BOROUGH OF OCEANPORT

AGENDA • OCTOBER 13, 2020

Re: Bulk Variances
74 Cayuga Avenue
Block 27, Lot 9
Borough of Oceanport, Monmouth County, New Jersey
MC Project No. OPP-264

Re: Preliminary and Final Site Plan
Triumphant Life Church
Block 110.07, Lot 1
Borough of Oceanport, Monmouth County, New Jersey
Application No. PB2018-13
MC Project No. OPP-262

FINAL ASBUILT SURVEY W/ TOPOGRAPHY		TAX LOT 9 BLOCK 27 74 CAYUGA AVENUE BOROUGH OF OCEANPORT MONMOUTH COUNTY NEW JERSEY	
DRAWING FILE: 20-8708LS00		PROJECT NUMBER: 20-8708 SHEET 1 REV. 1

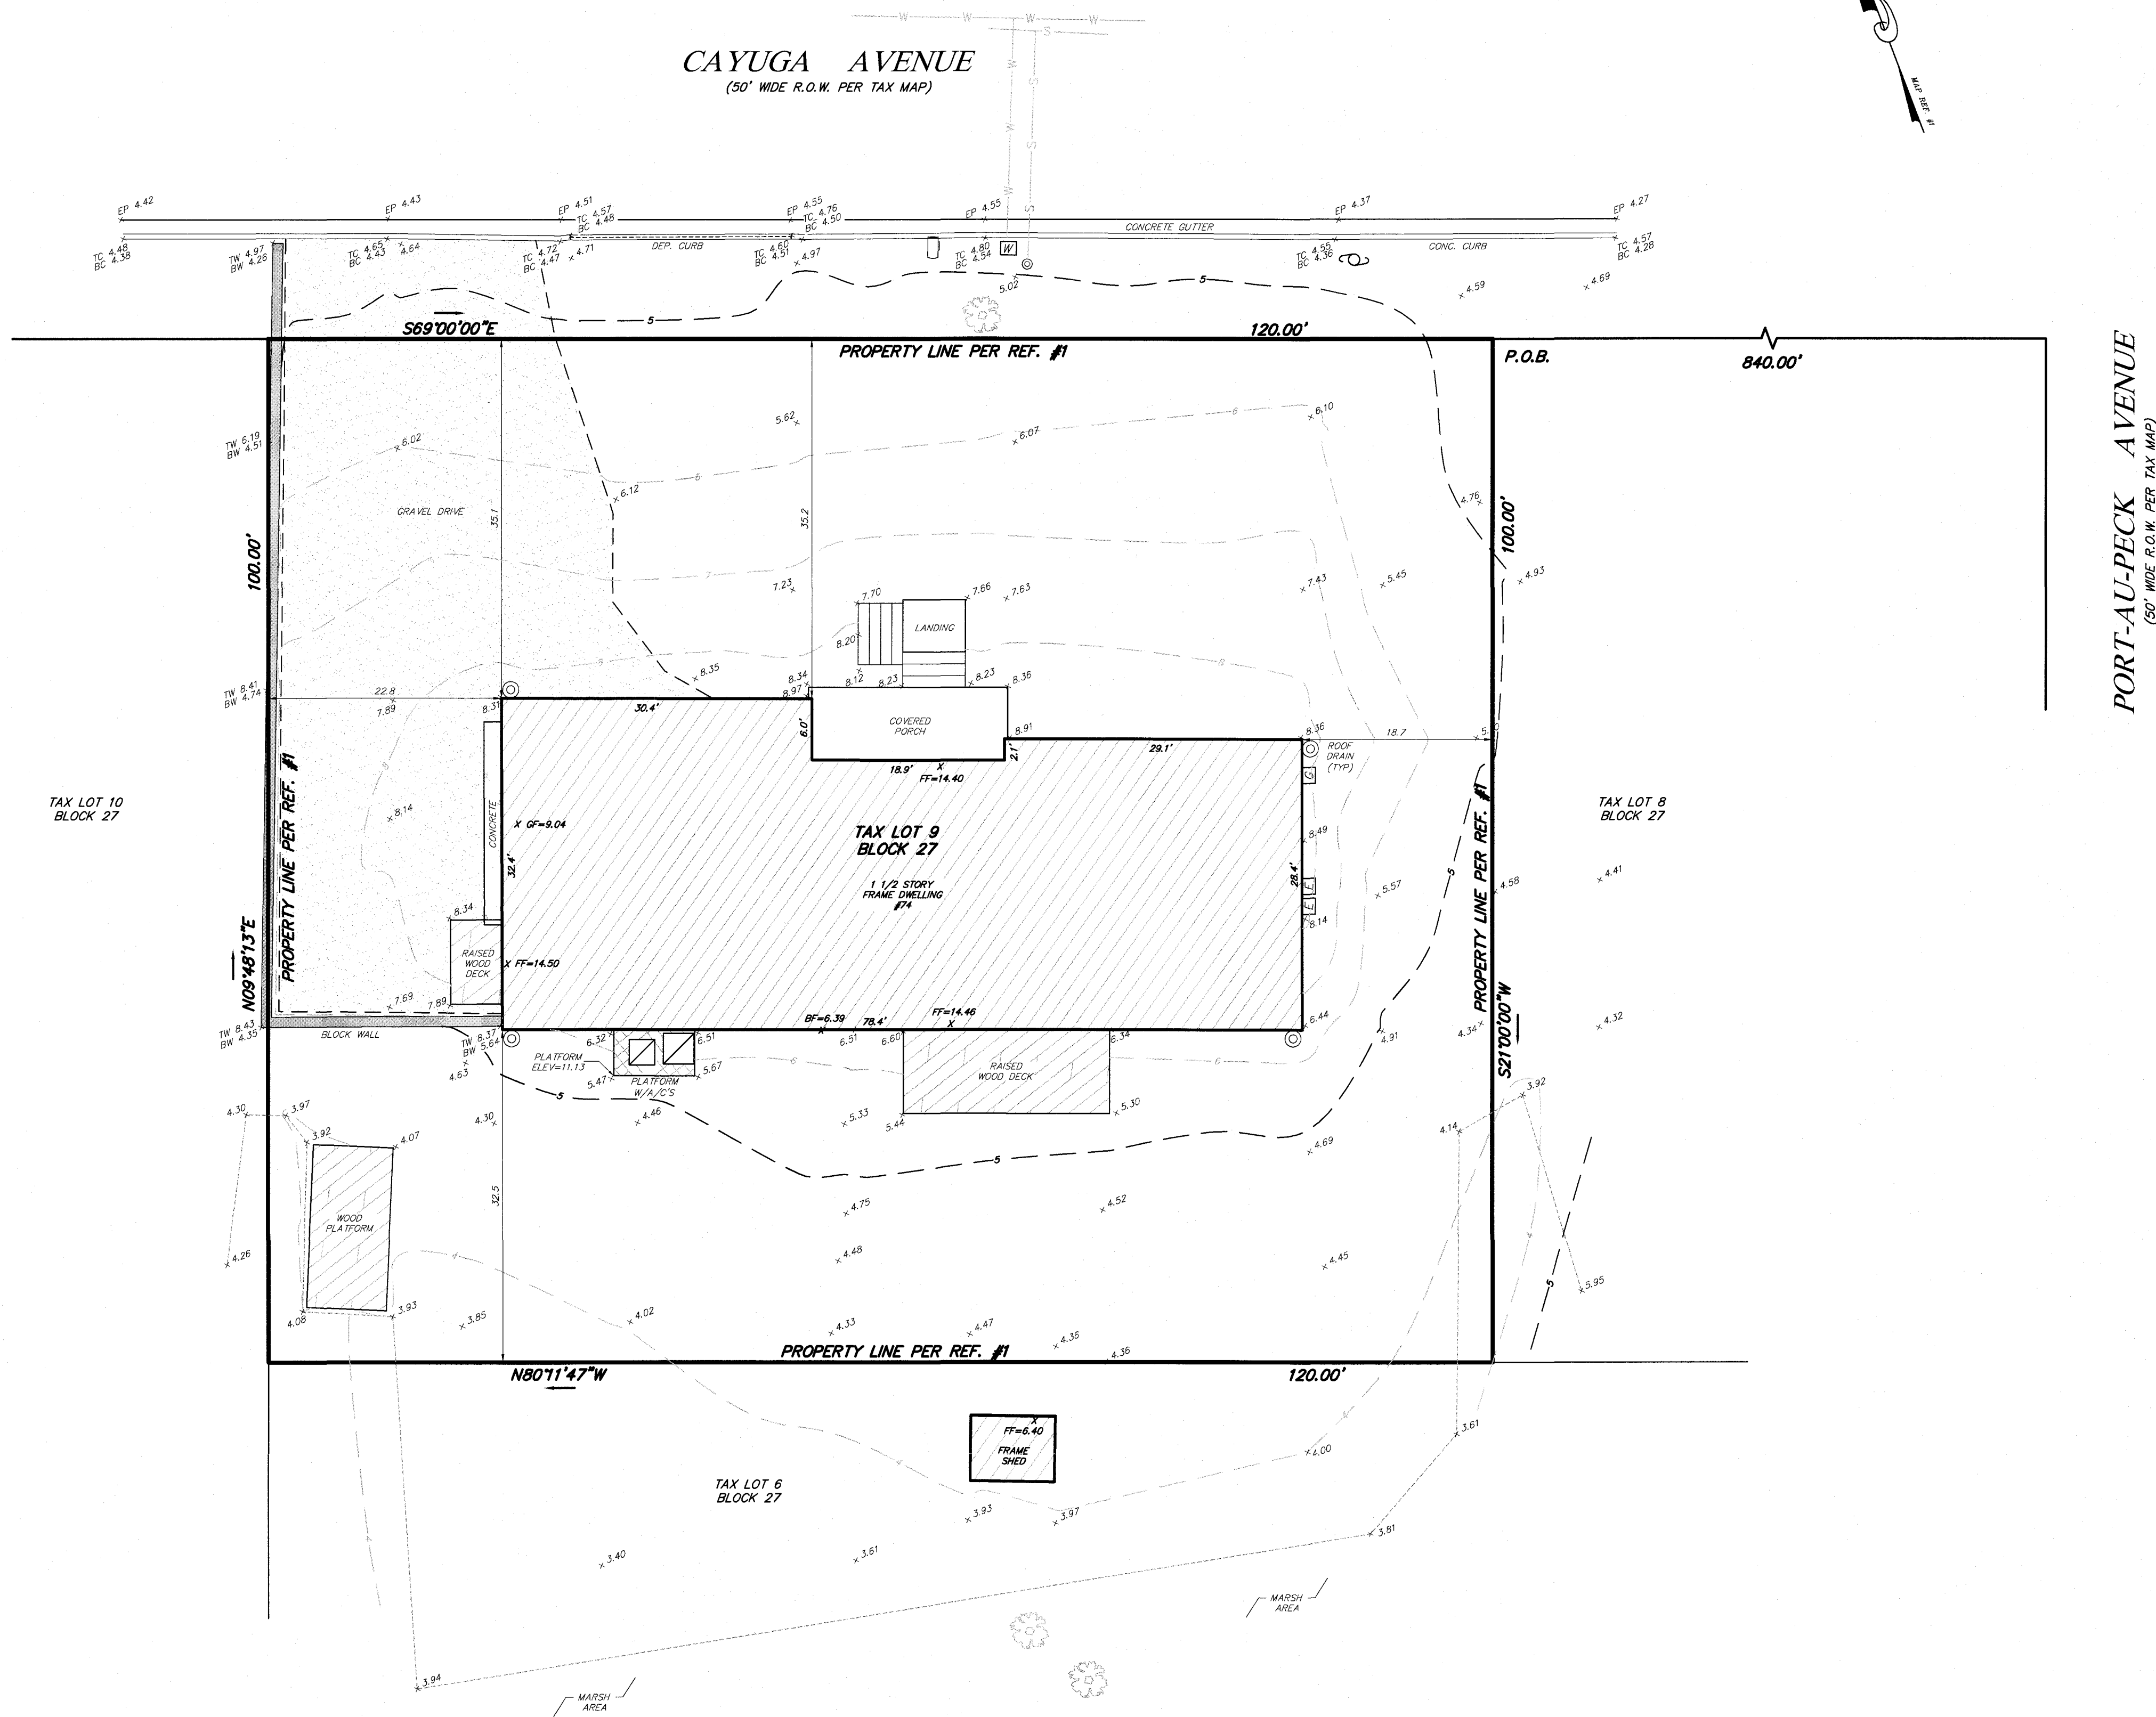
1. Bulk variances are required for the following:
 - a. Rear Yard Setback: 25 feet required, 24 feet proposed. A Bulk Variance is required.
 - b. Maximum Driveway Width (Ordinance 390-25k(1): 24' permitted, and the as-built condition provides a varying width up to 42'. The Applicant shall clarify the proposed surface and limits for the driveway. A Bulk Variance is required.
 - c. Driveway Side Yard Setback: 5' required from side property line, 0' is proposed. A Bulk Variance is required.
 - d. Retaining wall setback: 10 feet required from all property lines. The as-built survey indicates that the wall encroached into the abutting property. A Bulk Variance is required and an easement for the encroachment or the wall relocated.

1. The Architectural plans are not reflective of the structure that was built with respect to the front porch, rear deck and west side deck.
2. The driveway is only 22' wide at the side entry garage which is not sufficient for vehicles to make the necessary turning movements into and out of the garage. The industry standard is 28-32'. This dimension will be further reduced by the safety rail and fencing that is required.

3. A six foot deep apron constructed of concrete, asphalt, pavers, etc. shall be provided at the entrance to the driveway as required by Ordinance 390-25k(2). If the entire driveway will be paved this will address this requirement.

4. Structural calculations are required for the guide rail along the elevated driveway to provide fall over protection to vehicles. In addition, a pedestrian guard is needed for the area where the wall exceeds 30" in height.

5. Structural calculations are required for the segmental block wall that demonstrate the wall is designed to withstand the impact load on the guiderail system. Since the wall is already built a certification from a New Jersey licensed Engineer certifying that the wall is structurally sound and provides the appropriate Factors of Safety

6. There appears to be a shed and another structure beyond the rear property line on the adjacent park land which is not permitted by Green Acres as this property is deed restricted. These

items shall be removed or relocated onto the subject property and the appropriate setback provided. The approximate 8' x 16' platform appears to have been a shed that was partially destroyed. The Applicant shall clarify if it will be rebuilt and if so, will the proper setbacks be provided.
